#### NOTICE OF VIOLATION

On July 22, 2024, Energy Safety conducted an inspection of SCE's WMP initiatives in the vicinity of the city of Porterville, California. The inspection report is enclosed herewith. Energy Safety found the following violation(s):

## **INSPECTION REPORT**

Exhibit A: Photo Log Structure ID: 1294218E

Item1IA1Img1: No covered conductor present

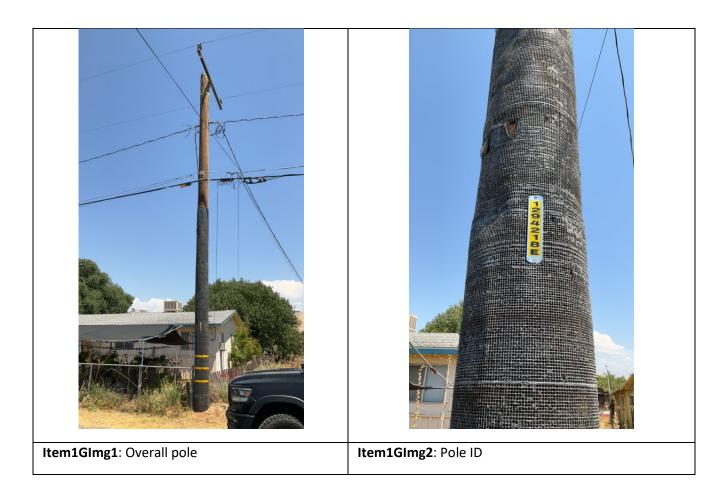
On pole ID 1294218E, Grid Hardening ID TD2021365-1294218E, at 250 S. Page St, Porterville, CA 93257, 36.06130120437438, -118.97198579343933, the inspector observed that no covered conductor was present. The inspector's observation is documented in Violation 1 photographs, which are attachments to this report. Photo numbers Item1GImg1, Item1GImg2, and Item1IA1Img1 depict that no covered conductor was installed at the location.

- 1. Southern California Edison Company's 2023 WMP Covered Conductor (8.1.2.1.1) work was identified as complete at this location.
- 2. Covered conductor was not installed.
